SUBJECT: Historic Area Work Permit: 846182: Building Additions

The Montgomery County Historic Preservation Commission (HPC) has reviewed the attached application for a Historic Area Work Permit (HAWP). This application was **Approved** at the October 24, 2018 Historic Preservation Commission meeting with revised plans approved at the September 11, 2019 HPC meeting and the February 12, 2020 HPC meeting.

Applicant: David O'Neil and Laura Billings Address: 5904 Cedar Parkway, Chevy Chase

### **Billings O'Neil Residence HAWP Revision 2**

#### Living Room 1st Floor - North Elevation

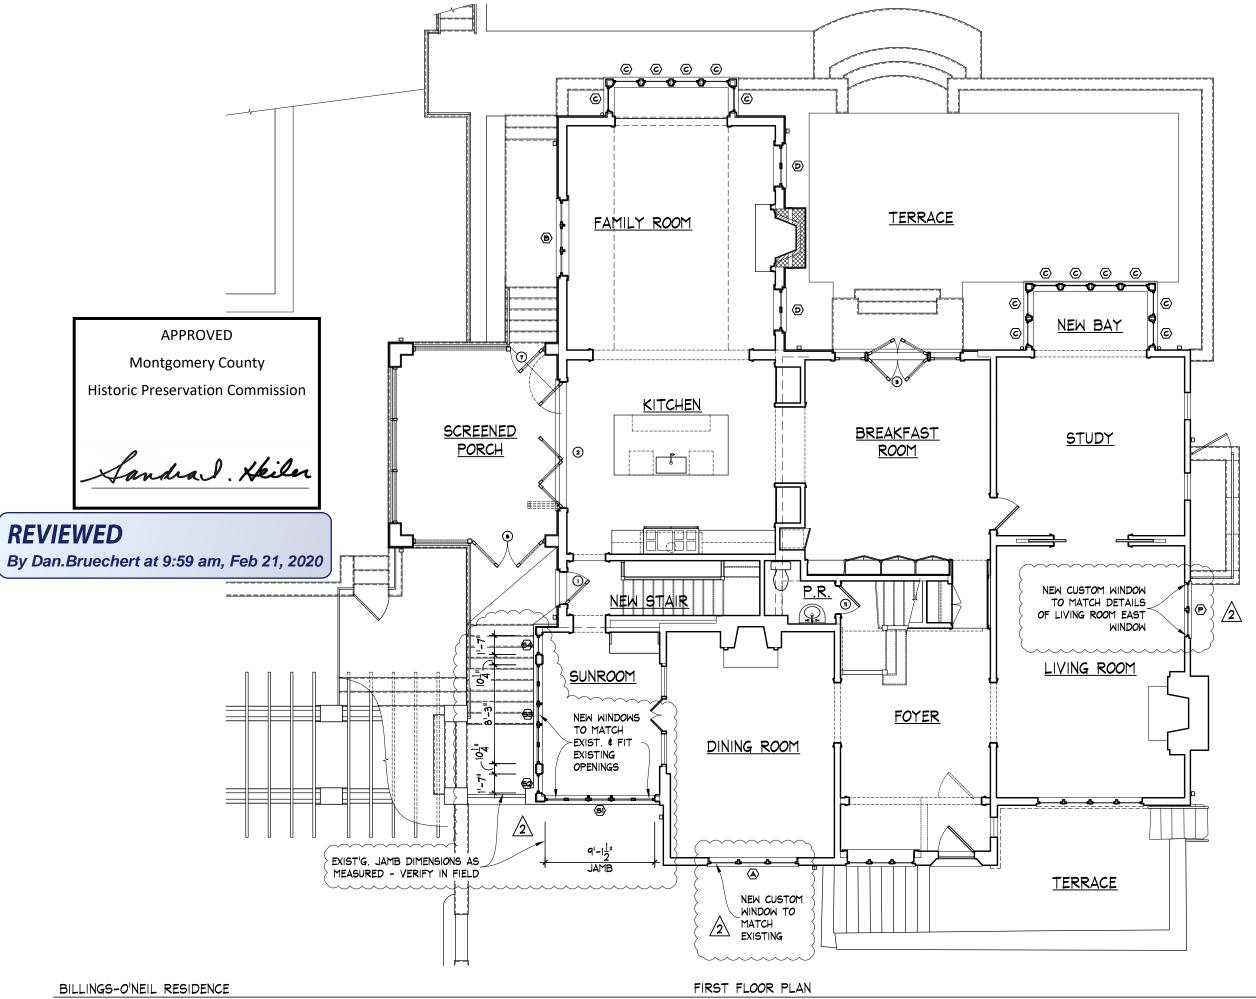
This window is rotted and will not operate (photo 11). We propose to replace with a custom unit to fit the opening and match the details of the Living Room window on the east elevation.

#### Bedroom 1 on 2<sup>nd</sup> Floor – North Elevation

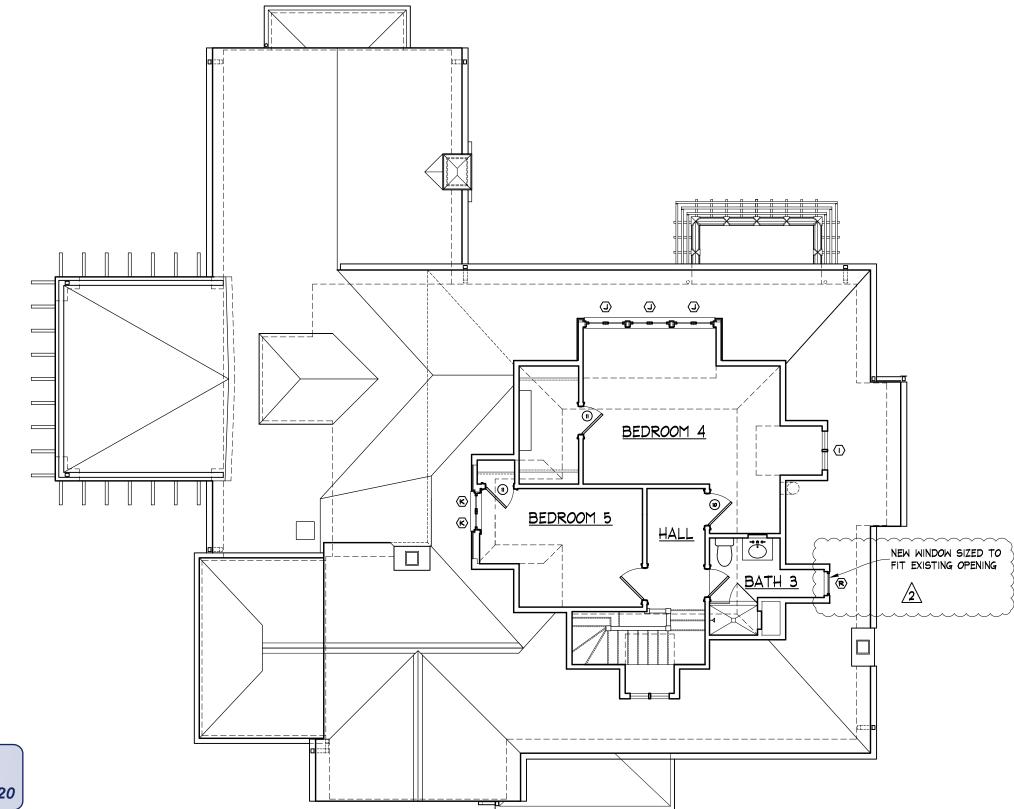
This window is rotted and will not operate (photo 12). We propose to replace with an operable window to match.
